CITY OF ALBUQUERQUE

RE: **Lot 20 Block 5 Unit 18 SAD 228**
6616 Sujeto NW
Volcano Cliffs Subdivision
Grading and Drainage Plan
Engineers Stamp Date 8/20/2020 (D10D003K20)
Pad Certification Date 9/14/2020

ENGINEER'S SEAL	LOT 20 BLK 5 UN 18 VOLCANO CLIFFS 6616 SUJETO ROAD, N.W.	DRAWN BY DEM
DAVID SOULE NEW MEXICO REGISTERED PROFESSIONAL ENGINEER 3/15/20	GRADING AND DRAINAGE PLAN	DATE 3-12-20
DAVID SOULE P.E. #14522	Rio Grande Engineering 1608 CENTRAL AVENUE SE SUITE 201 ALBUQUERQUE, NM 87106 (505) 972-0899	LOT 20 BLK 5 UN 18 VOLCANO CLIFFS DWG
		SHEET # C1
		JOB #

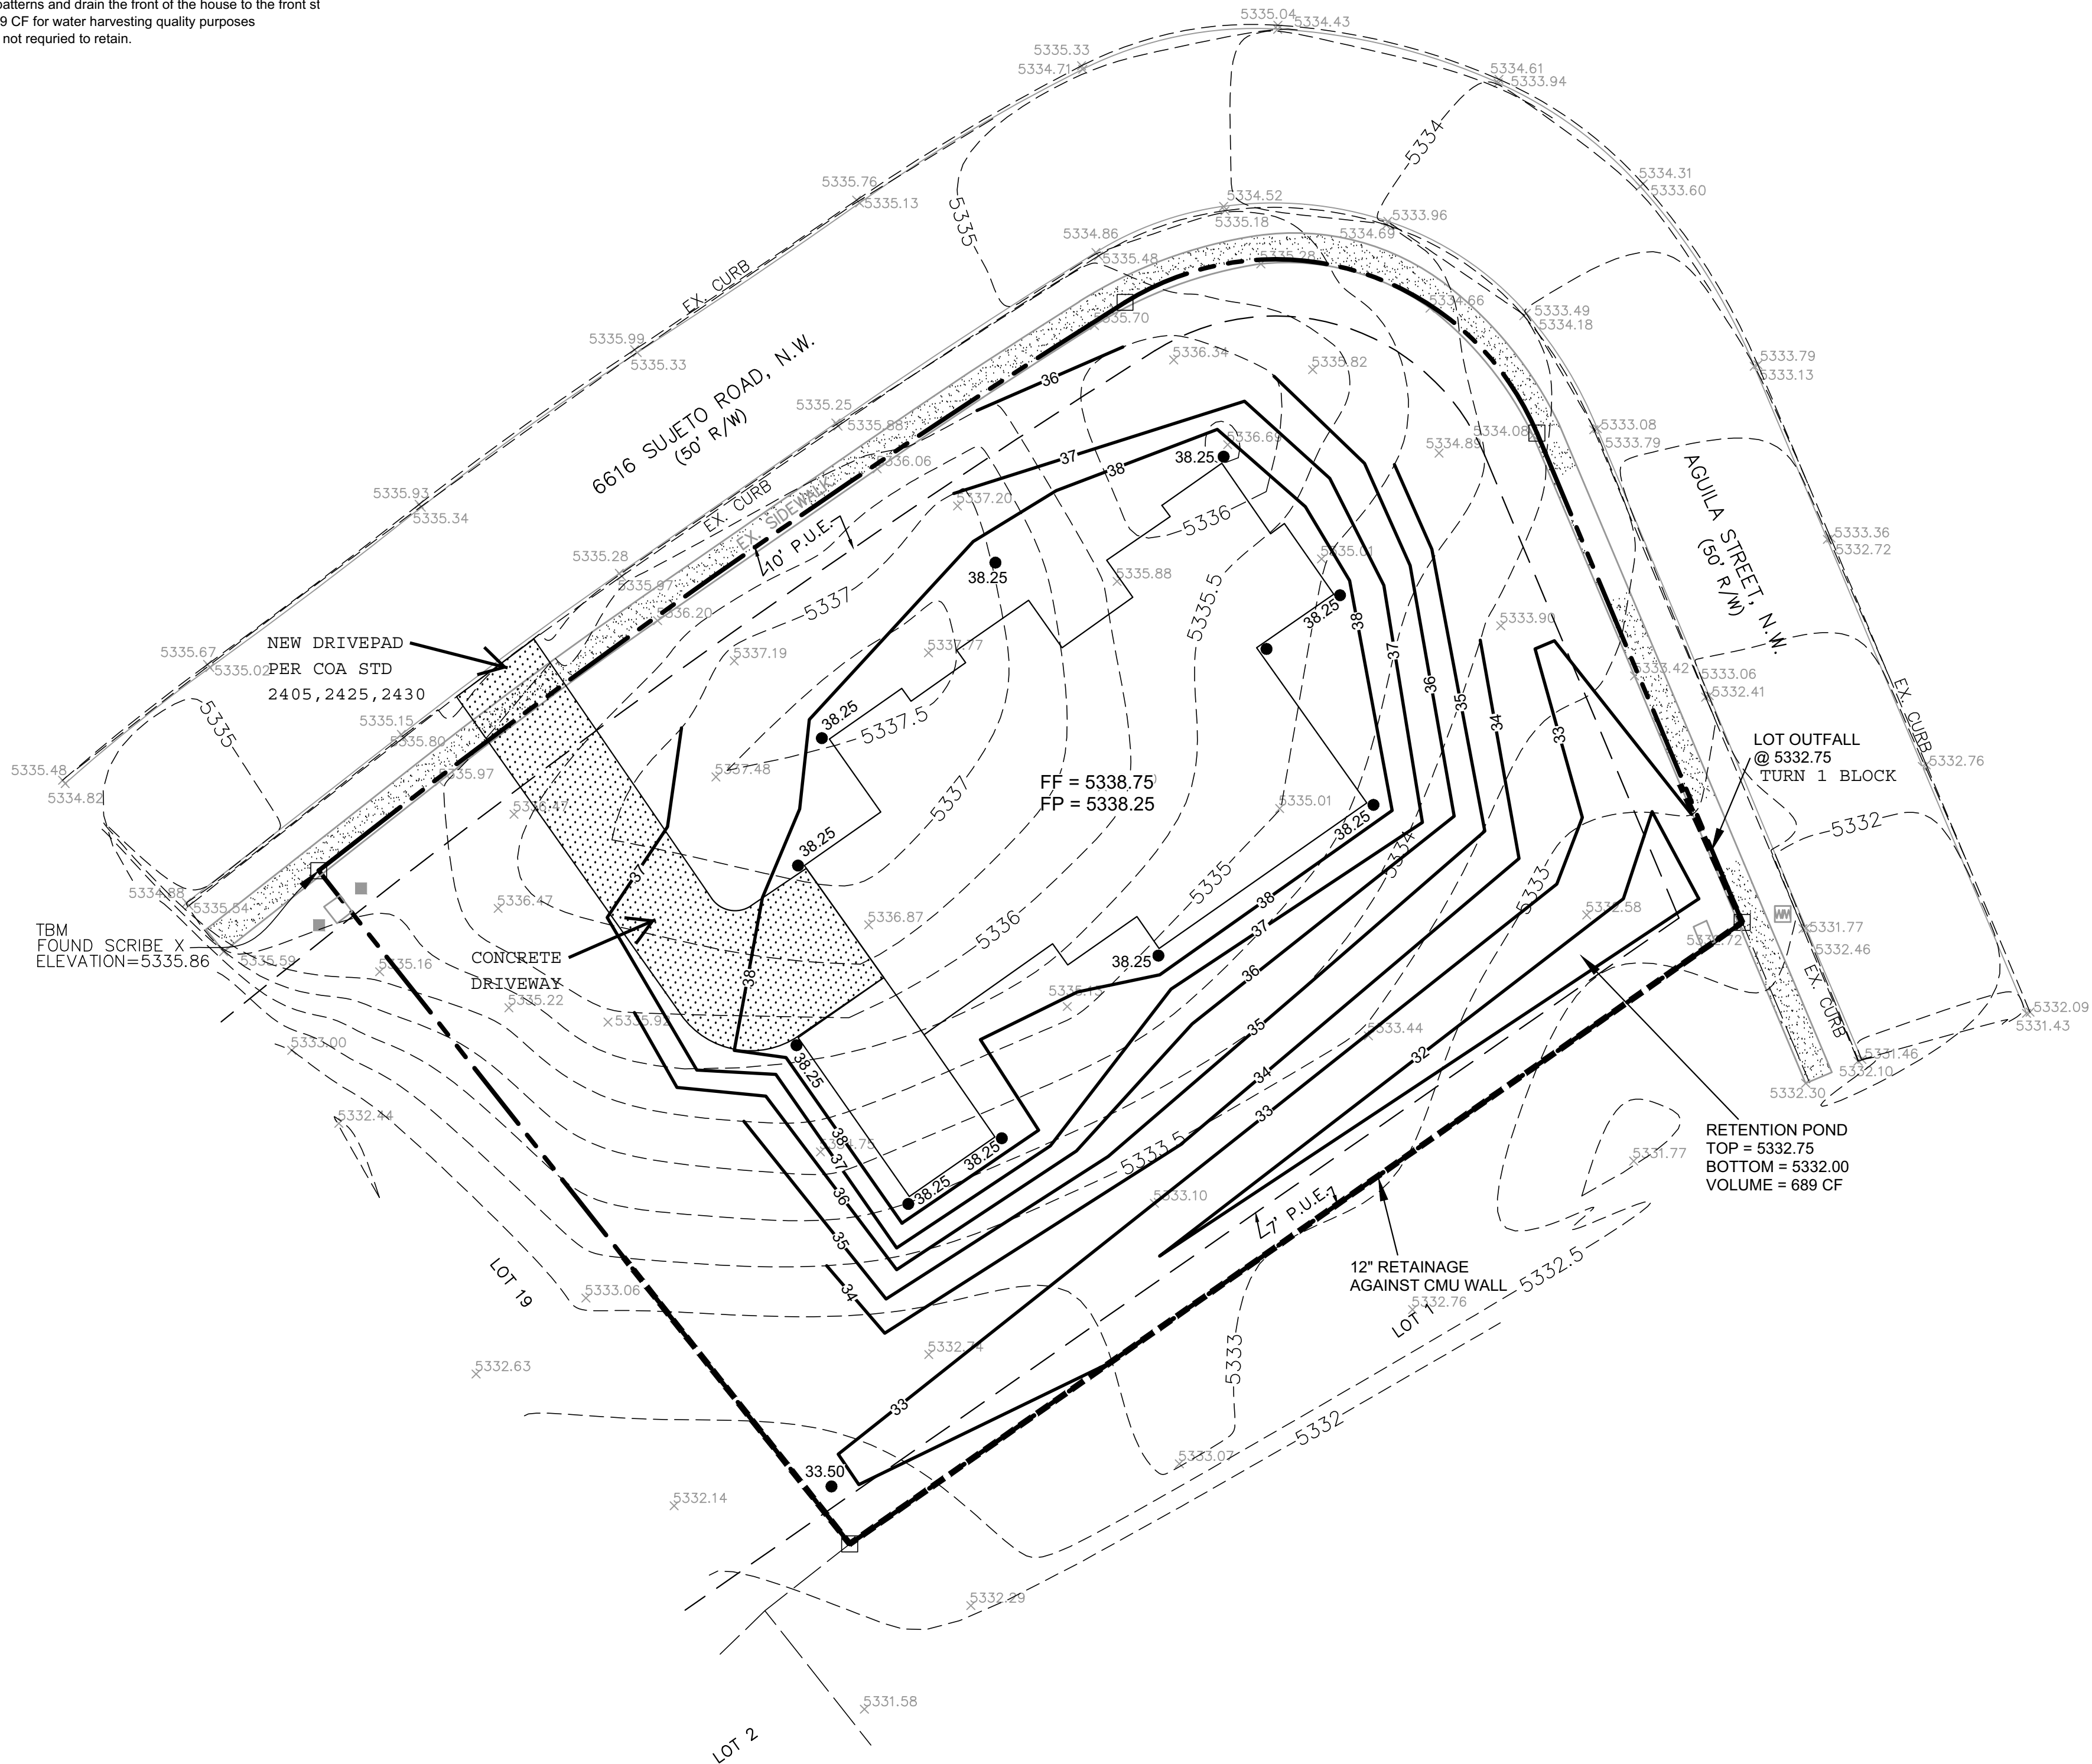
Based upon the information provided in your submittal received 9/14/2020, this plan is approved for Building Permit.

Reiterate to the Owner/Contractor that a separate permit for a garden/retaining wall must be obtained, with the approved G&D plan dated 8/20/2020 and Pad Certification dated 9/14/2020.

Prior to Certificate of Occupancy release, Engineer Certification per the DPM checklist of this plan will be required.
